Addendum No. 2  
Regional Carrizo Project - Schertz Parkway Pump Station  
SAWS Job No. 10-8617  
SAWS Solicitation No. B-11-061-RA

## **ADDENDUM NO. 2**

March 19, 2012

- A. The purpose of this addendum is to issue revisions to the plans and specifications for the Regional Carrizo Project - Schertz Parkway Pump Station (SAWS Job No. 10-8617; SAWS Solicitation No. B-11-061-RA).

**C-210**  
 Sheet: 11 of 130

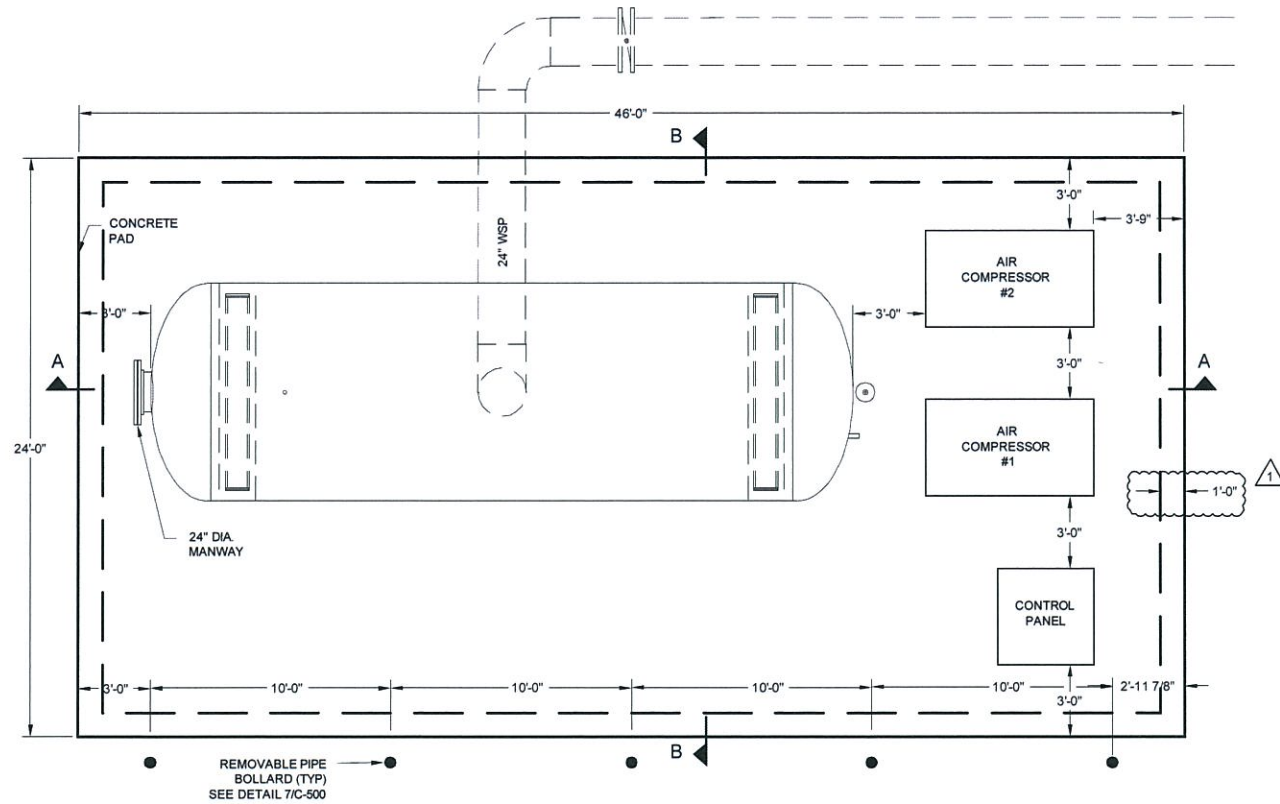
- B. Sheet C-210 (11 of 130)
1. Note 6, revise design pressures for welded steel pipe as indicated in the revised Sheet C-210 included in this Addendum No. 2. Changes are indicated with revision clouds.

- NOTES:**
1. ALL WATER LINE PIPING SHALL BE WELDED STEEL PIPE WITH RESTRAINED JOINTS, UNLESS OTHERWISE NOTED.
  2. ALL VALVES IN THE PRODUCTION FACILITY SHALL BE "OPEN LEFT". VALVE BOX COVERS SHALL BE CAST WITH "OPEN LEFT" ON LID.
  3. ALL VALVE BOXES SHALL BE TRAFFIC RATED.
  4. ALL VALVES SHALL BE NORMALLY OPEN (N.O.) UNLESS OTHERWISE NOTED AS NORMALLY CLOSED (N.C.).
  5. ALL PIPING AND FITTINGS TO BE PAINTED PER PROJECT SPECIFICATIONS.
  6. DESIGN PRESSURE FOR WELDED STEEL PIPE SHALL BE AS FOLLOWS:

PIPELINE	DESCRIPTION	PIPE DIAMETER	WORKING PRESSURE (PSI)	TRANSIENT/TEST PRESSURE (PSI)
WATERLINE 'A'	SUPPLY PIPE	36 INCH	177	266
WATERLINE 'B'	TANK OUTLET	48 INCH	177	266
PUMP SUCTION HEADER	BURIED SUCTION HEADER	48 INCH	177	266
PUMP STATION PIPING	PUMP SUCTION PIPING	30 INCH	177	266
PUMP STATION PIPING	PUMP DISCHARGE PIPING	24 INCH	177	266
PUMP DISCHARGE HEADER	BURIED DISCHARGE HEADER	36 INCH	177	266
WATERLINE 'C'	YARD PIPING TO NACO PS	36 INCH	177	266
WATERLINE 'D'	EMERGENCY RETURN	24 INCH	177	266

**SAN ANTONIO WATER SYSTEM**  
REGIONAL CARRIZO PROJECT  
SCHERTZ PARKWAY PUMP STATION  
**HYDROPNEUMATIC SURGE TANK #1**  
SPPS

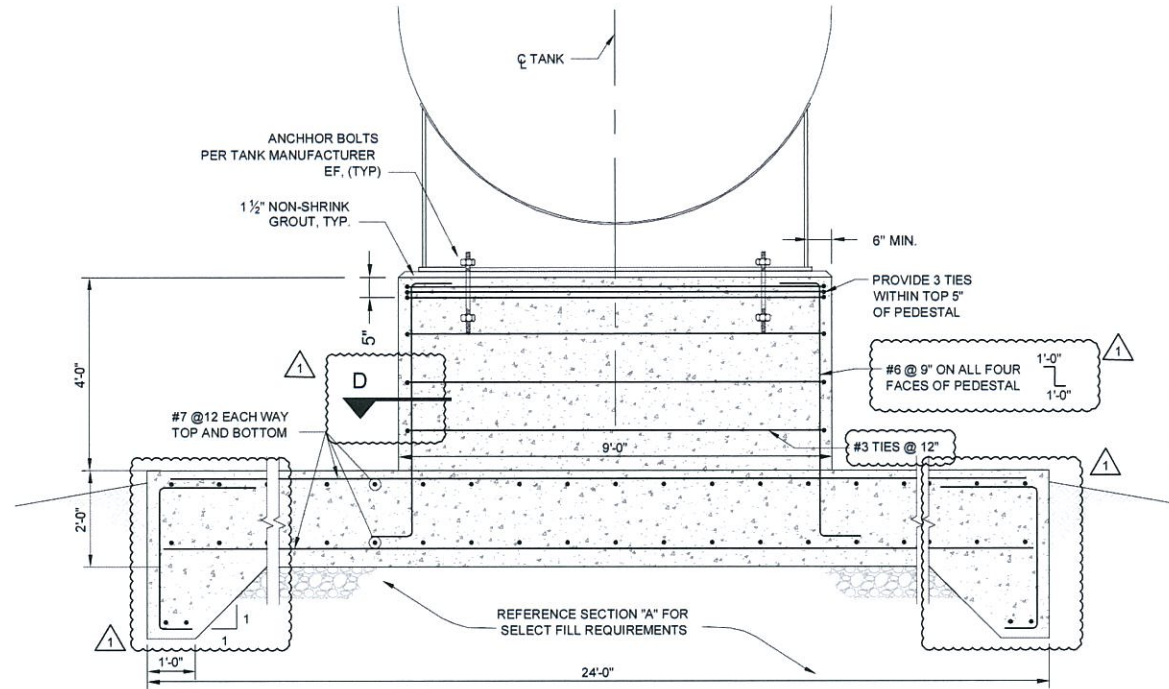
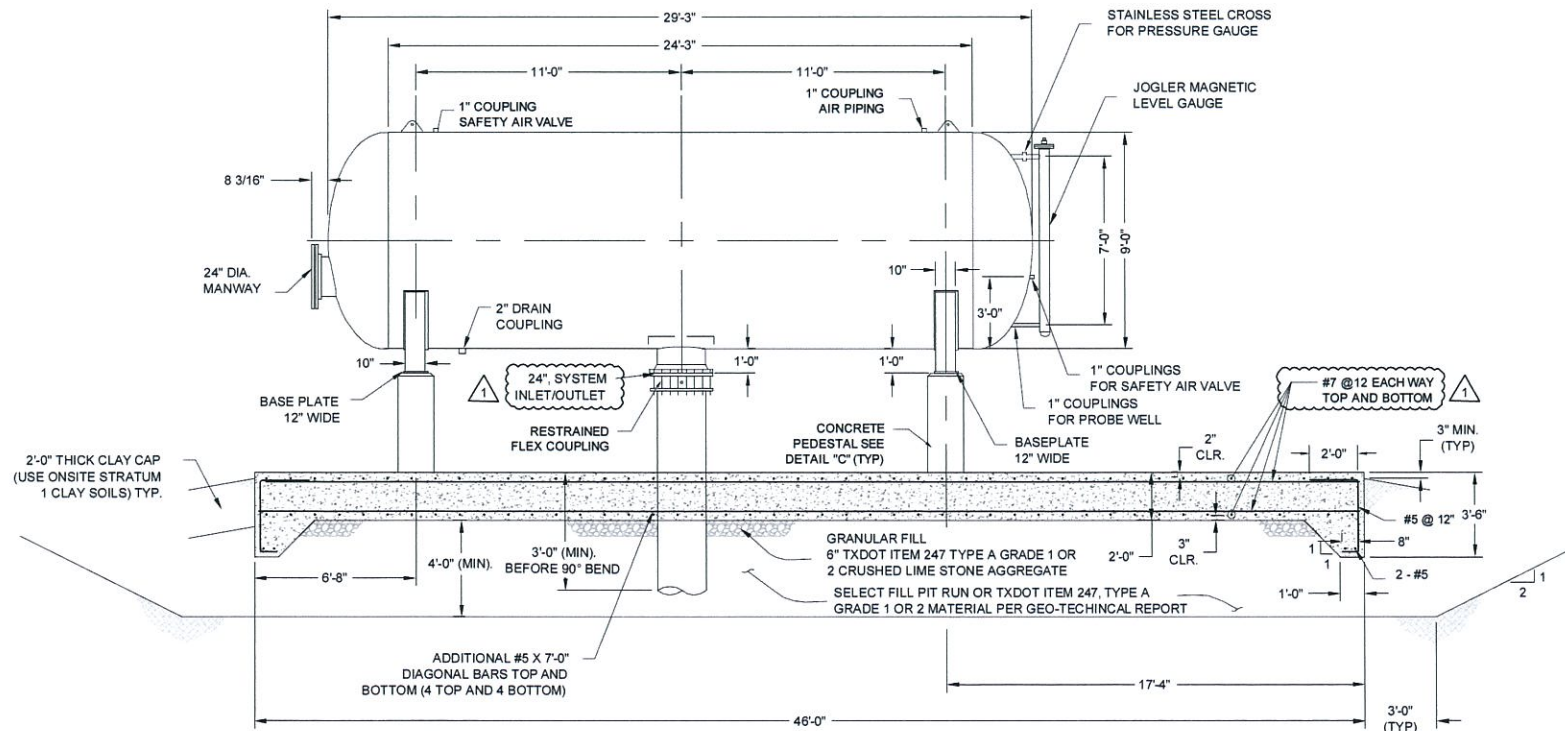
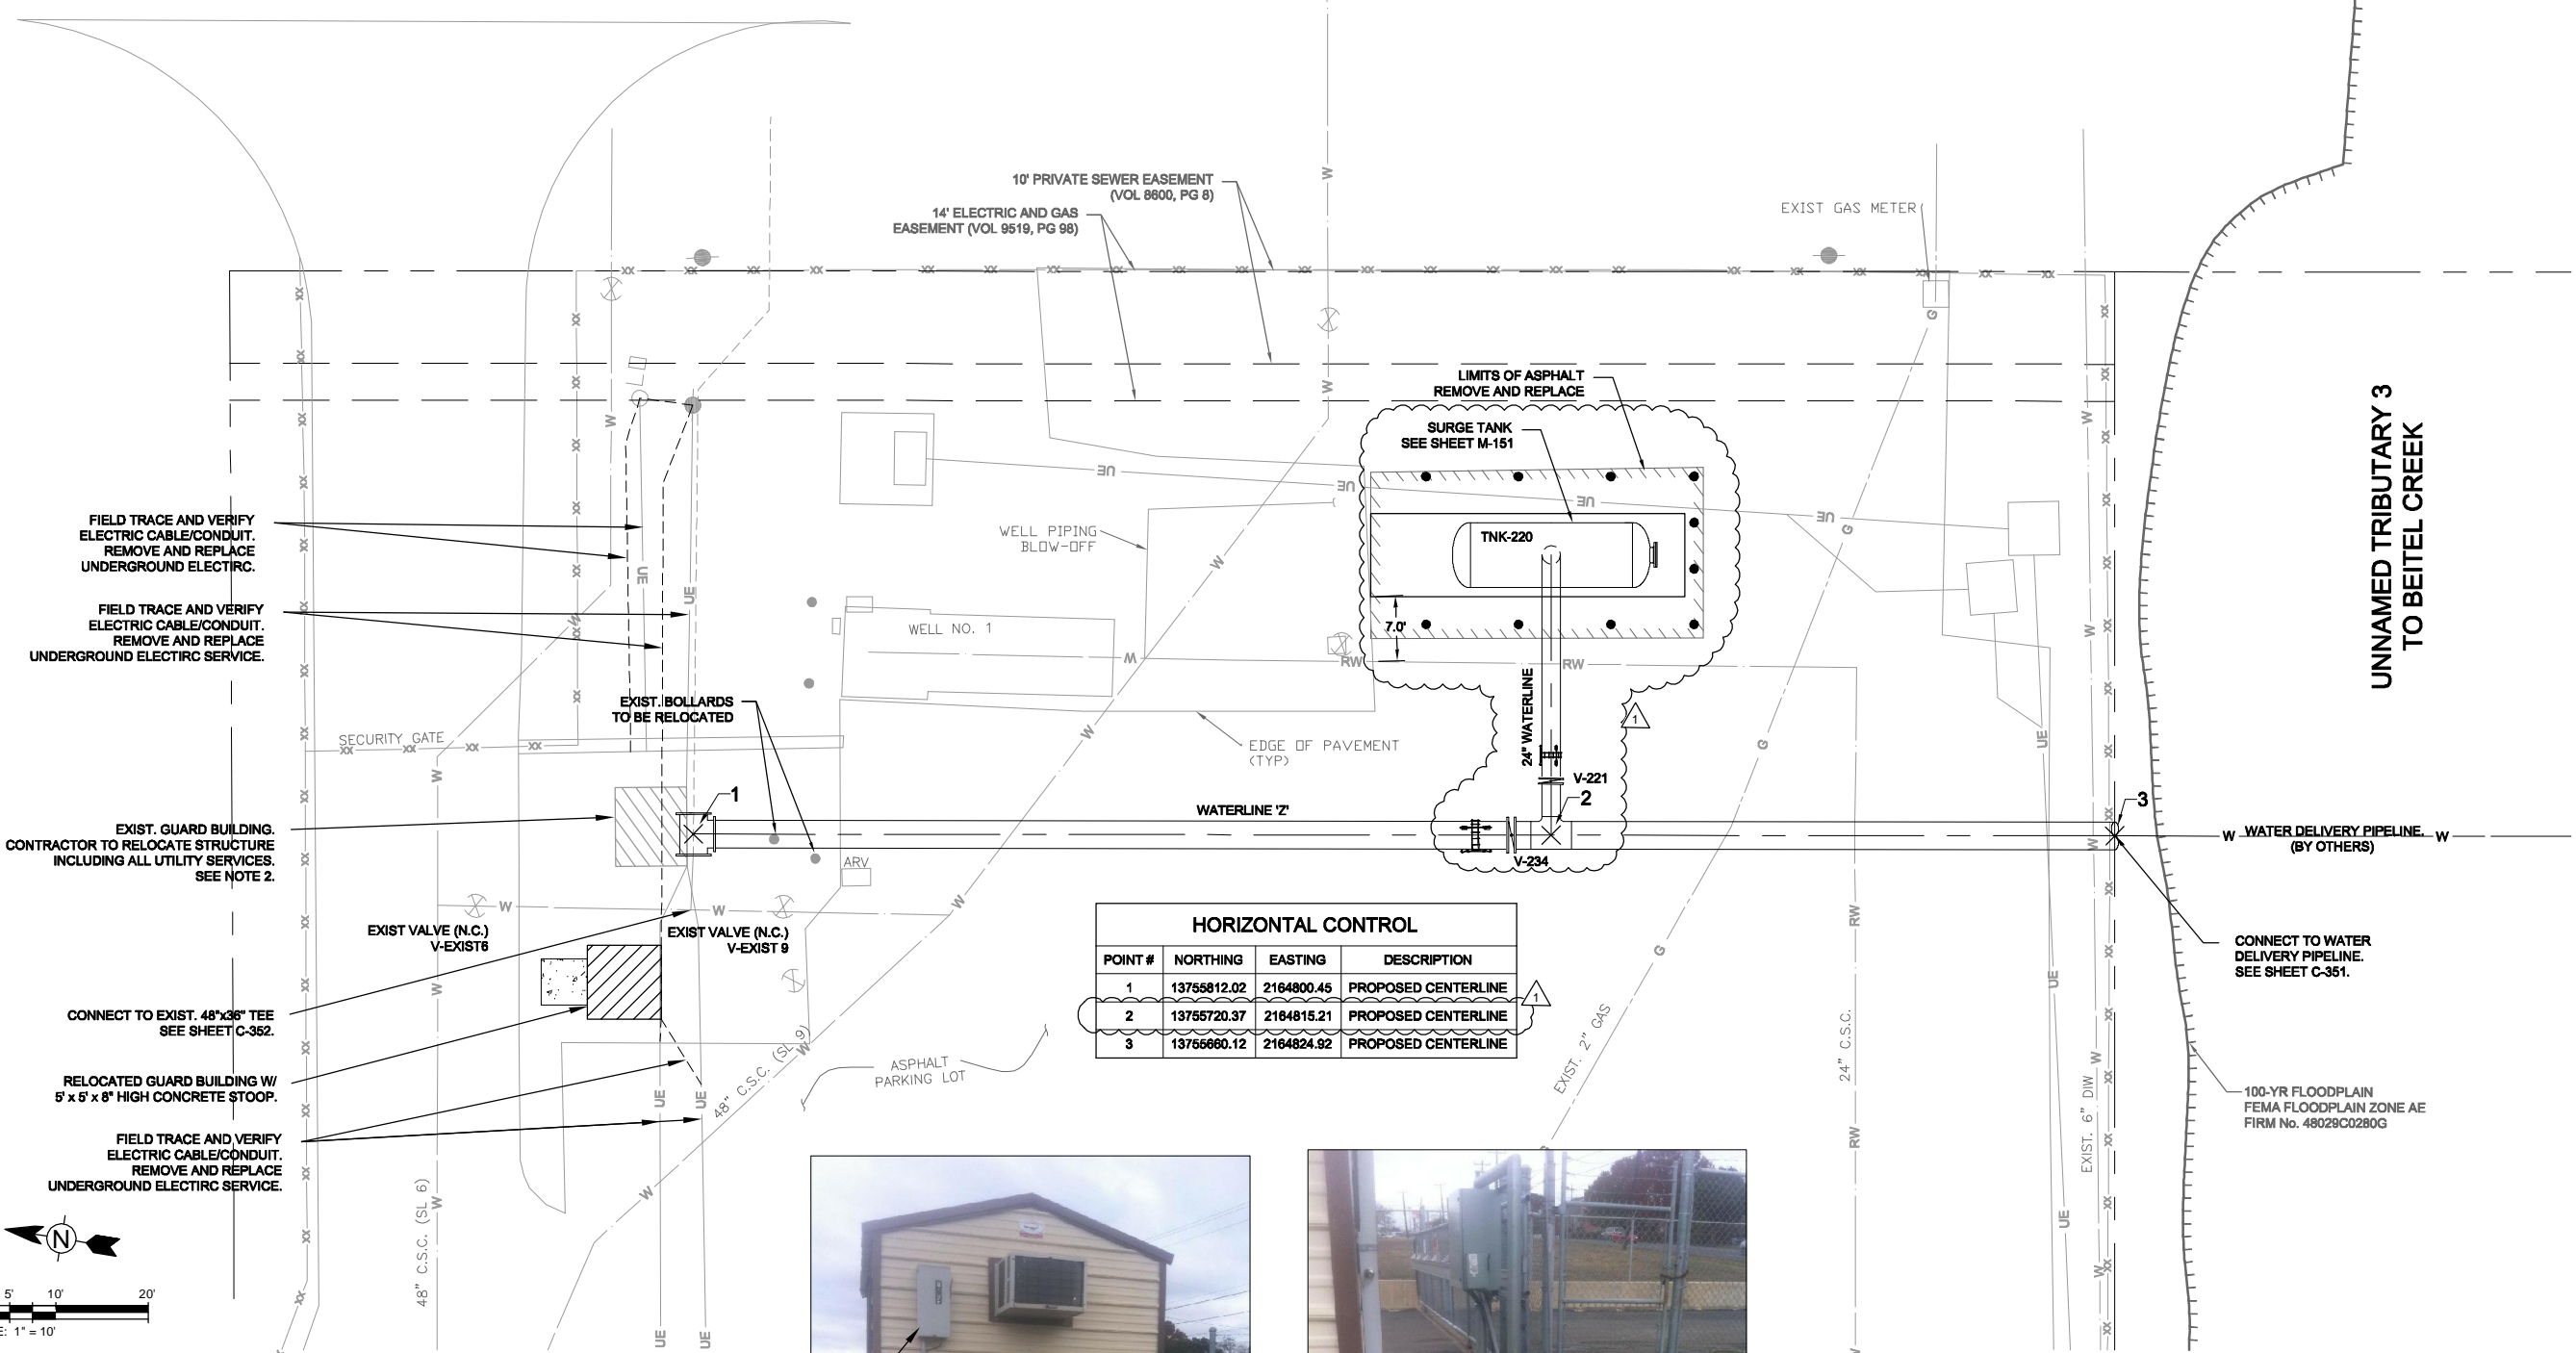
- C. Sheet M-112 (29 of 130)
2. Revise concrete footing as indicated in the revised Sheet M-112 included in this Addendum No. 2. Changes are indicated with revision clouds.

**C-252**  
 Sheet: 95 of 130  
 Bar Measures 1 inch

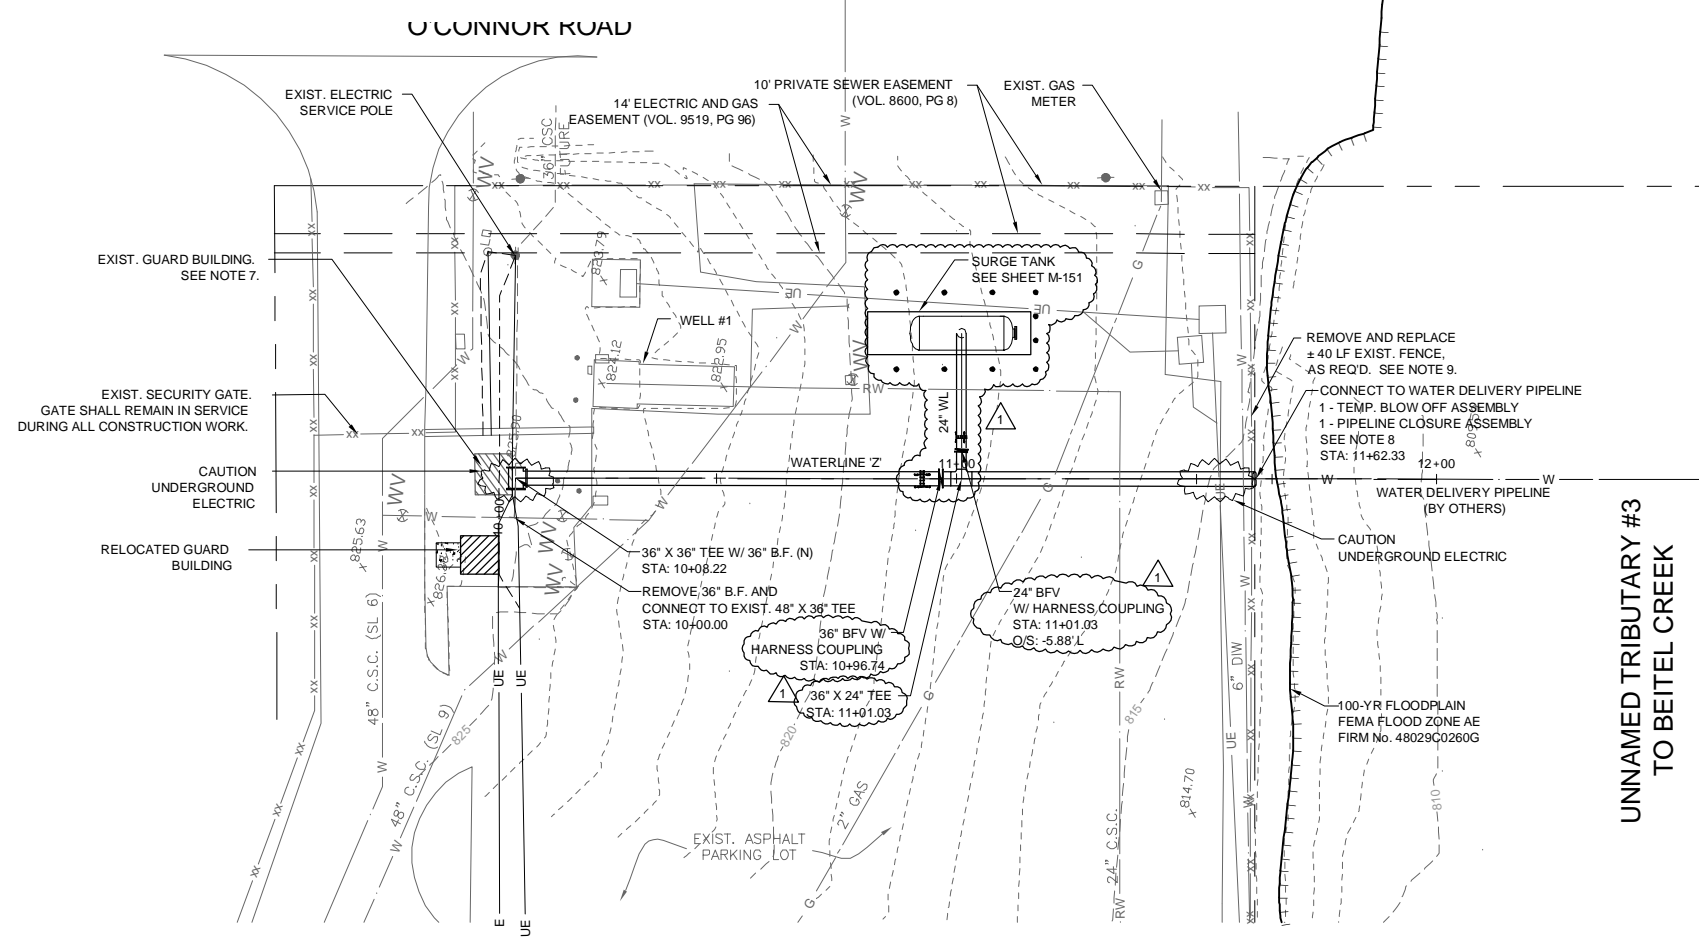
- D. Sheet C-252 (95 of 130)
3. Revise location of Surge Tank #2 as indicated in the revised Sheet C-252 included in this Addendum No. 2. Changes are indicated with revision clouds.
